UNITED NATIONS		E
	Economic and Social	Distr. GENERAL
	Council	GENERAL
	Council	ECE/TRANS/WP.11/214/Add.1
		14 December 2006
		ENGLISH
		Original: ENGLISH AND FRENCH

REPORT OF THE WORKING PARTY ON ITS SIXTY-SECOND SESSION (6-9 November 2006)

Addendum 1

Draft amendments to the ATP adopted at the sixtieth and sixty-first sessions

Model of certification plate:

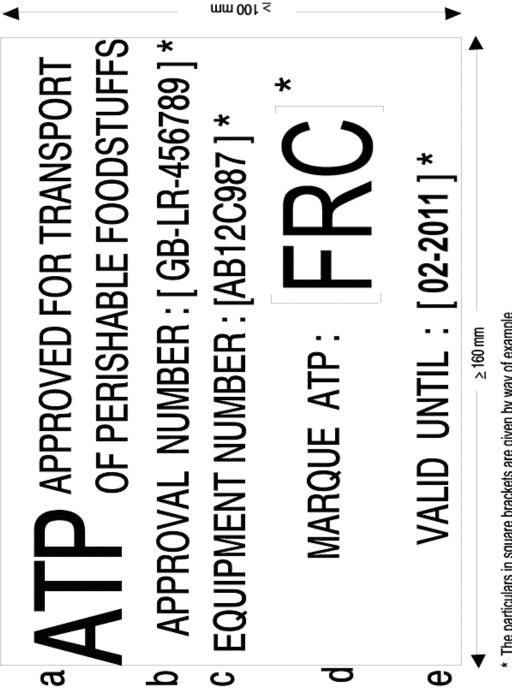
Replace with the following:

* The particulars in square brackets are given by way of example
